WELL API NO. 30-015-42797
5. Indicate Type of Lease STATE <input type="checkbox"/> FEE <input checked="" type="checkbox"/>
6. State Oil & Gas Lease No.
7. Lease Name or Unit Agreement Name Cedar Canyon 15 SWD
8. Well Number 1
9. OGRID Number 16696
10. Pool name or Wildcat SWD Devonian-Silurian
11. Elevation (Show whether DR, RKB, RT, GR, etc.) 2928'

**SUNDRY NOTICES AND REPORTS ON WELLS**  
 (DO NOT USE THIS FORM FOR PROPOSALS TO DRILL OR TO DEEPEN OR PLUG BACK TO A DIFFERENT RESERVOIR. USE "APPLICATION FOR PERMIT" (FORM C-101) FOR SUCH PROPOSALS.)

**Attachment C-103  
 OXY USA Inc  
 Cedar Canyon 15 SWD #1  
 API No. 30-015-42797**

OXY USA Inc.  
CedarCanyon 15 SWD #1  
API No. 30-015-42797

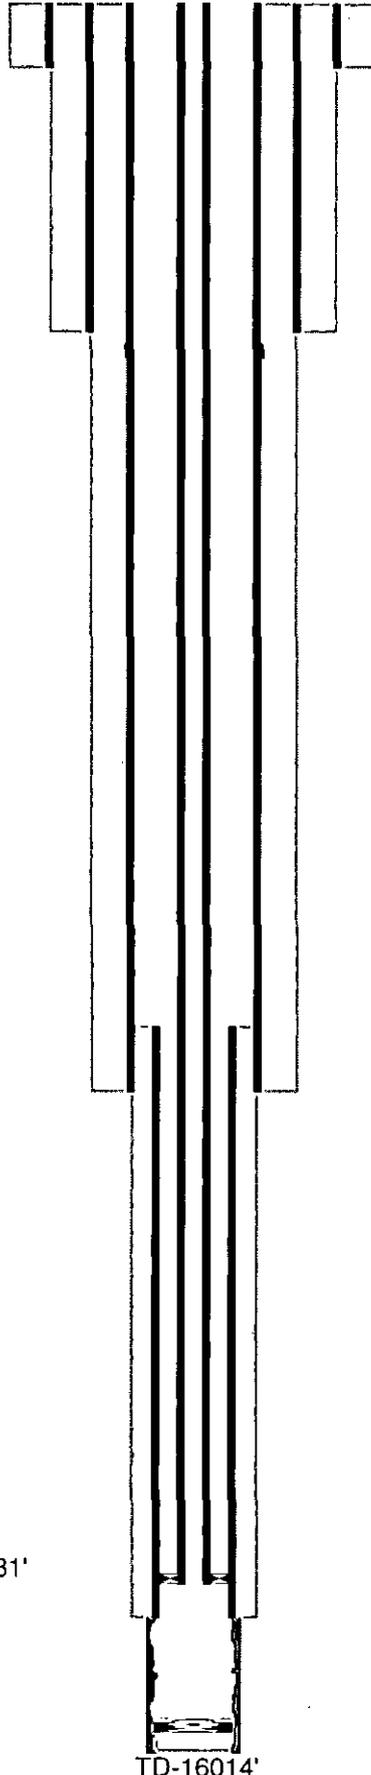
**OXY respectfully requests to change the injection tubing string as follows:**

- a. Stop injection operations
- b. Pull existing 4-1/2” 11.6# L-80 tubing out of the hole
- c. Run new tubing string of 5-1/2” 20# L-80 BTC to 9655’ (100’ above top of 7” liner) X/O to 4-1/2” 15.1# L-80 BTC to 14,781’. Both tubing strings will be lined internally with Duoline anti-corrosion lining
- d. OXY will notify NMOCD 24hrs prior to running MIT

**DENIED**

TUBING SIZE SPECIFIED IN SWD ORDER. YOU MUST  
 SUBMIT A CHANGE TO THE SWD ORDER TO  
 ALLOW FOR INCREASED TUBING SIZE.  
 CONTACT ENGINEERING BUREAU  
 IN SANTA FE.  
 See Attached  
 RE 7/12/16
